Hope Creek Generating Station
Facility Operating License No. NPF-57
NRC Docket No. 50-354

Subject: Response to Request for Additional Information
Request for License Amendment - Extended Power Uprate

Extended Power Uprate

Response to Request for Additional Information

Figure 3.24-1 Loss of Feedwater Long Term Level Response

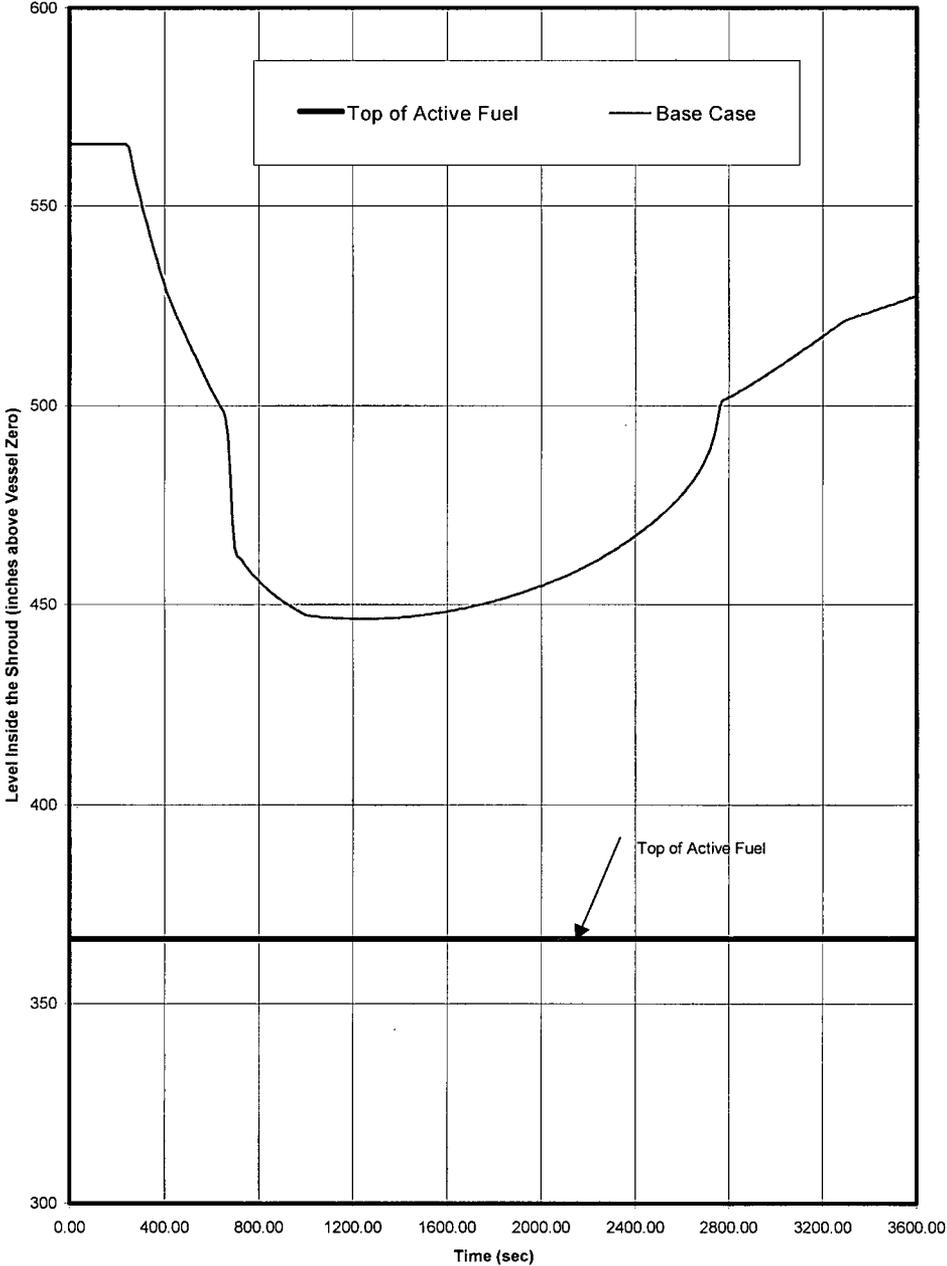
- 3.24 Please provide CPPU loss of feedwater flow and loss of one feedwater pump transient key parameter plots like Figures 9-1 to 9-4. For loss of feedwater transient, Hope Creek EPU mixed core (non GE-14 equilibrium) has different decay heat value than the one (GE-14 equilibrium) used in the analysis. How much does it affect the level recovery time? In terms of uncertainties, how does decay heat model used in your loss of feedwater flow analysis compare with the decay heat (decay heat \geq 1979 ANS + 10%) suggested in ELTR1? Please also provide an estimate of lowest inside core shroud level in this transient. How does the calculated lowest level compare to Level 1? In loss of one feedwater pump transient, was Level 3 scram avoided?

In general, decay heat is not a strong function of fuel product line or fuel manufacturer. A comparison study had been performed to compare the ANS 5.1-1979 Standard decay heat result of a SVEA 96+ bundle with that of a GE14 bundle of comparable enrichment. The resulting differences were well within the calculation uncertainties, and hence provided justification that the HCGS EPU decay heat bases remain valid for a mixed core of SVEA 96+/GE14.

Furthermore, the Loss of Feedwater safety analysis for determining the margin to the top of active fuel uses the ANS 5.1 1979 decay heat + 10%, bounding all fuel types used at HCGS. The lowest level inside the core shroud was calculated to be 446" above vessel zero, which is more than 6 feet above the top of active fuel. A separate nominal Loss of Feedwater analysis was performed to compare the level in the downcomer to the operational limit for Level 1 as it is desirable to avoid Level 1 during a complete loss of feedwater. The downcomer level in this analysis was 417" above vessel zero, which was about 11" above the Level 1 operational limit.
